Flood Hazard Area Delineation

Cherry Creek Minor Tributaries in Arapahoe County

Subject: Cherry Creek Minor Tributaries
In Arapahoe County
Major Drainageway Plan Flood Hazard Area Delineation
MHFD Agreement No. 18-08.13

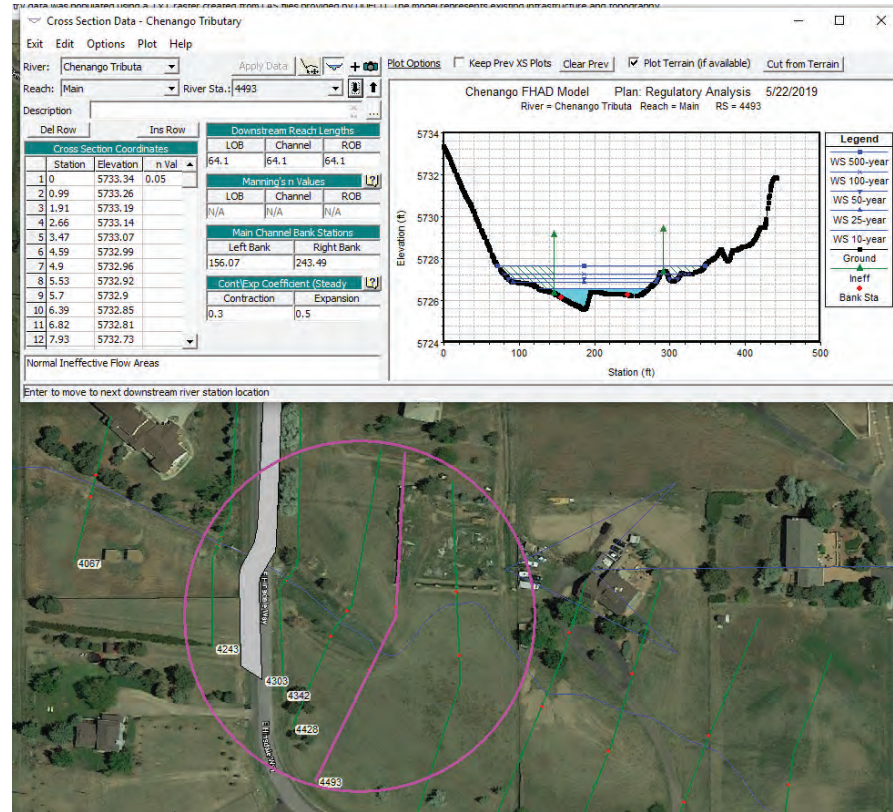
27. Contraction/expansion coefficients are appropriate

a. Do increased coefficients need to begin this far upstream of the culvert?

Response: Expansion/ contraction coefficients were generally applied along the full distance that contraction took place upstream of structures. The coefficients have been limited to the two XS's upstream instead of three.

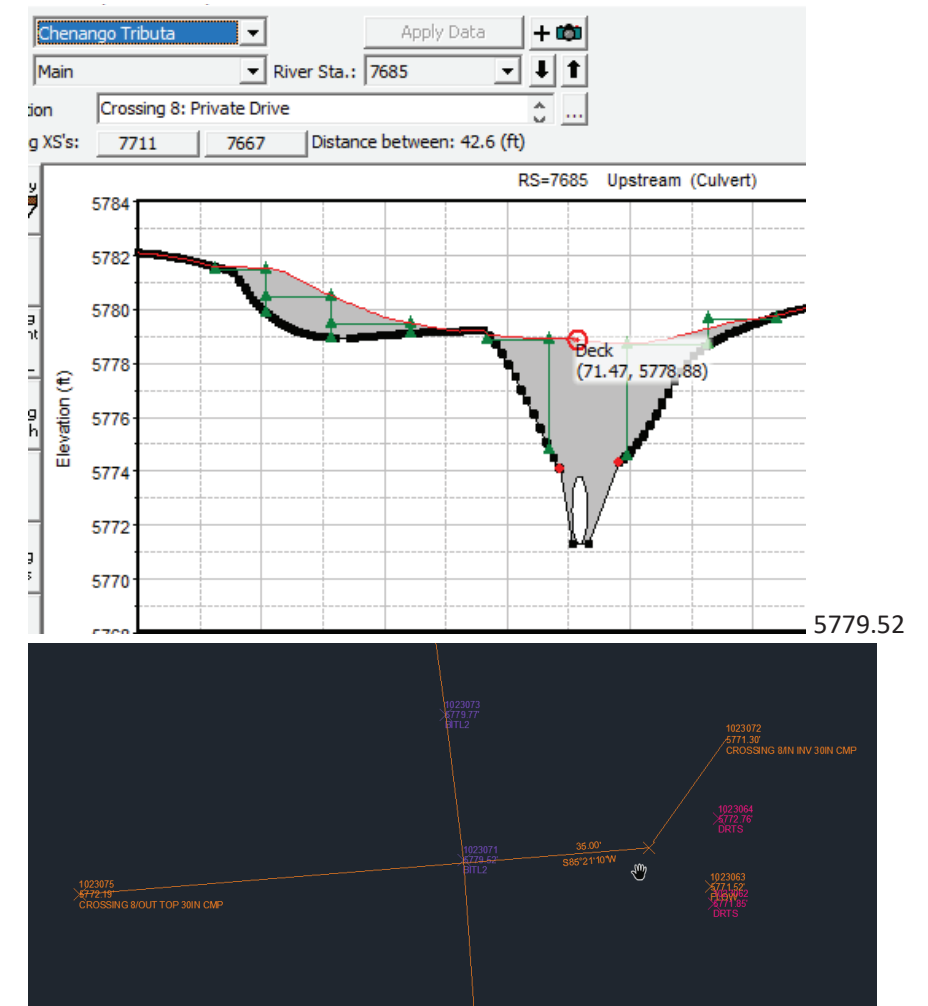
- d. Roadway crest elevations don't match?

Response: Road deck elevations have been modified by hand to correspond with the structure survey.

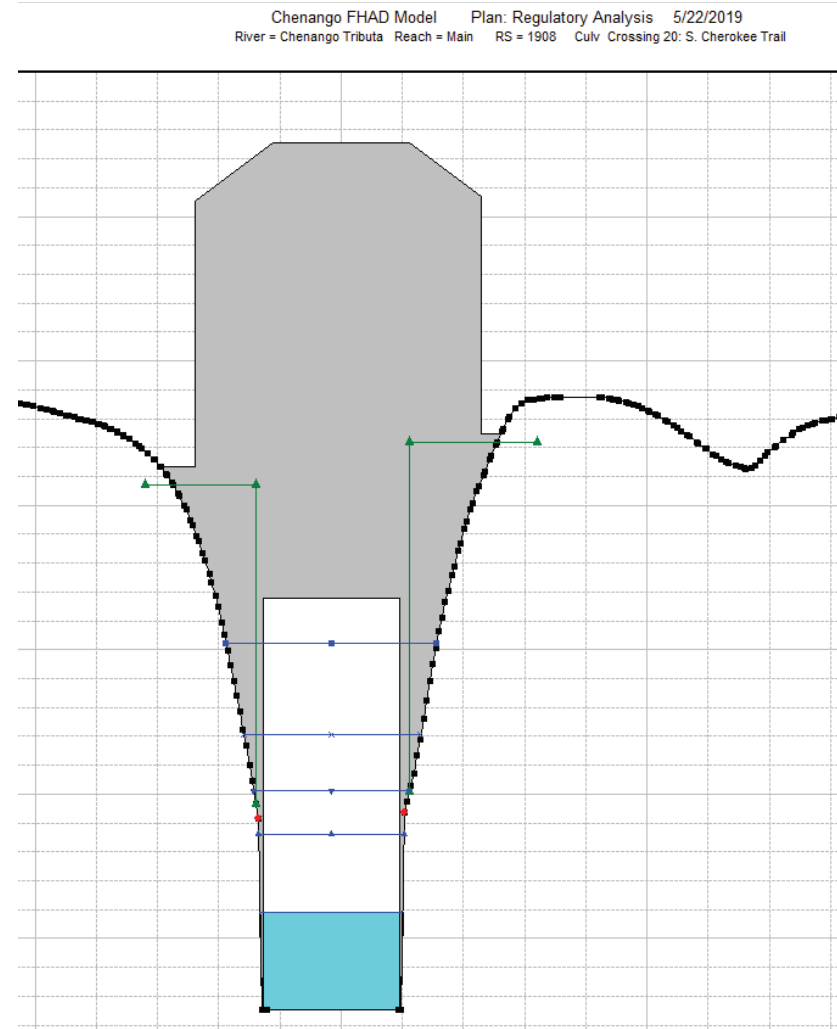
i. What exactly is happening here?

Response: The bridge deck has been modified by hand to reflect obstruction of flow that would be caused by the large chain-link fence located along the headwall of the culvert. The road crest is actually lower than the headwall elevation at this location, so embankment blockage is only represented by the headwall and chain-link fencing.

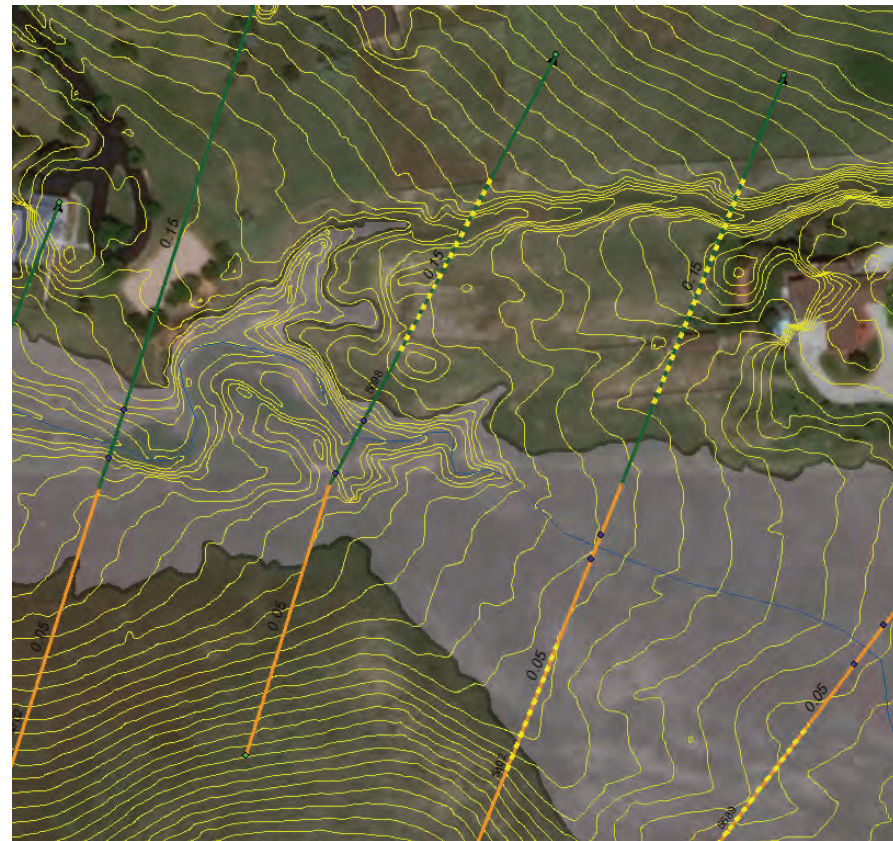
a. IEFA should start at the first XS station (or later) – and why is this not normal IEFA on the

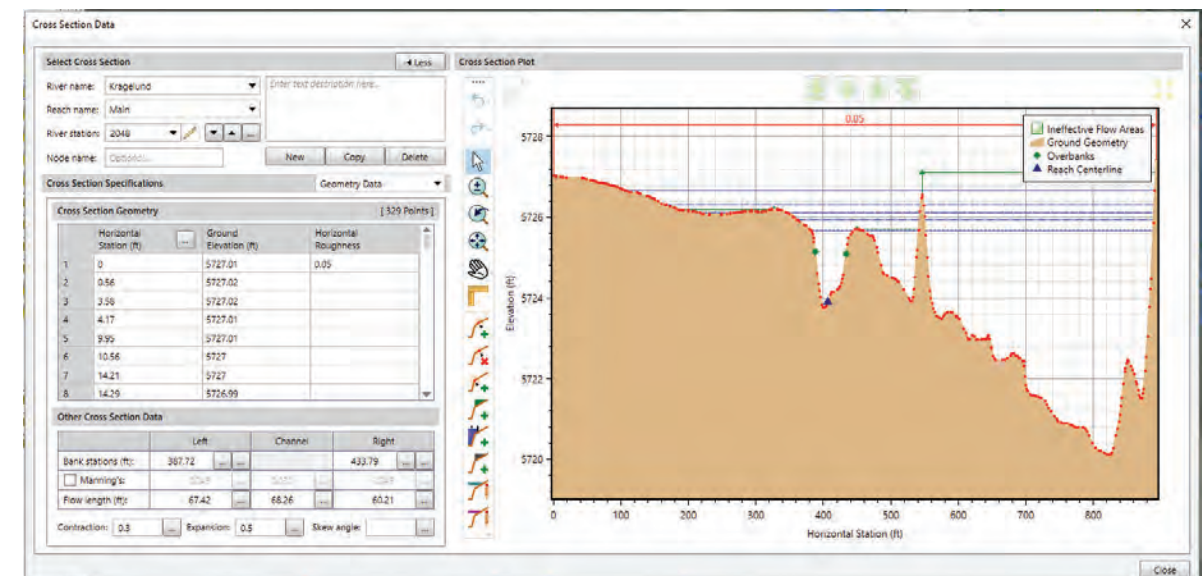
g. Is it realistic to force all the flow to remain north of the road and flow into the culvert? The topo (as well as the lack of any defined channel downstream of Parker Rd.) suggest this is not what happens.

Response: Refer to response 15.A. and 26.E. The model now reflects ponded flow on the south side of Mineral Place and while peak flow is likely reduced by weir flow over the road, the full peak Q is kept past Parker Road for future conditions which might result in all of the flow making it through the culvert.

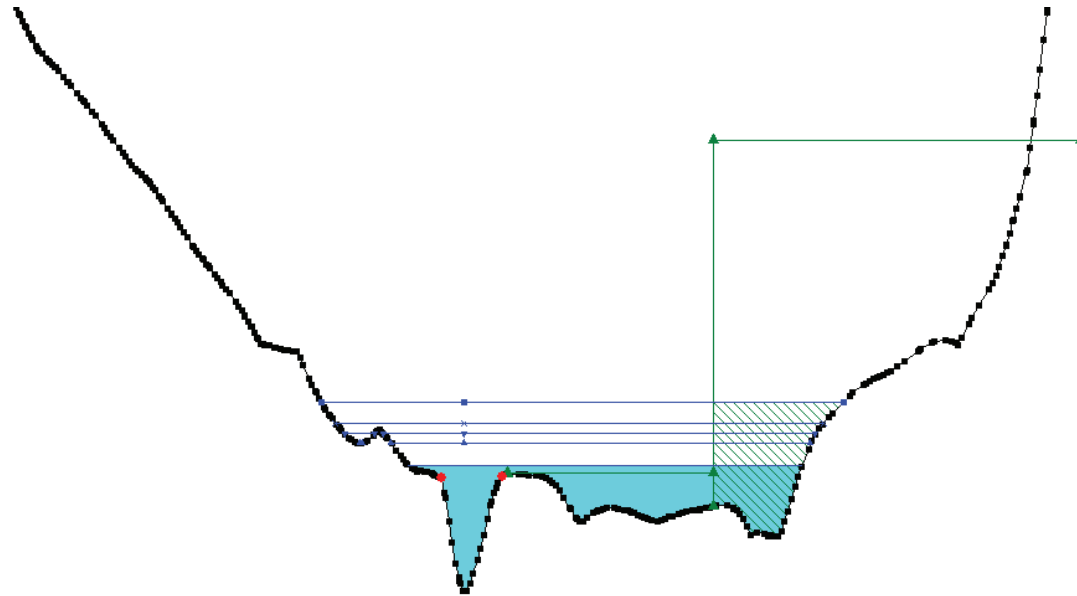
Modify bank stations as follows:

Response: Modified XS 5103 so that resemble actual bank edges.

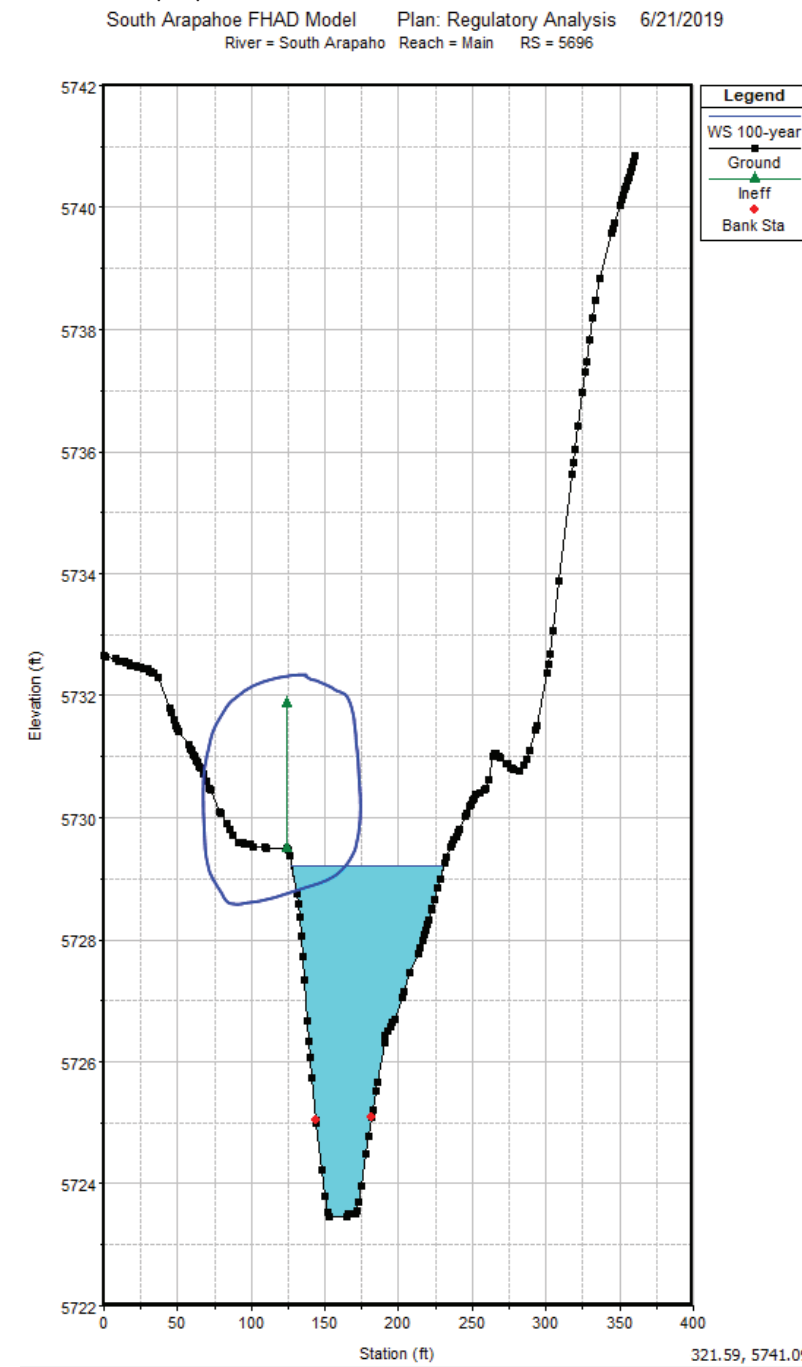
30. Lateral Structures:
 - d. HW/TW stationing
 - i. Please add descriptions to lateral structures.

Response: Descriptions will be added to lateral structures as necessary if used in the modeling approach chosen for this area.
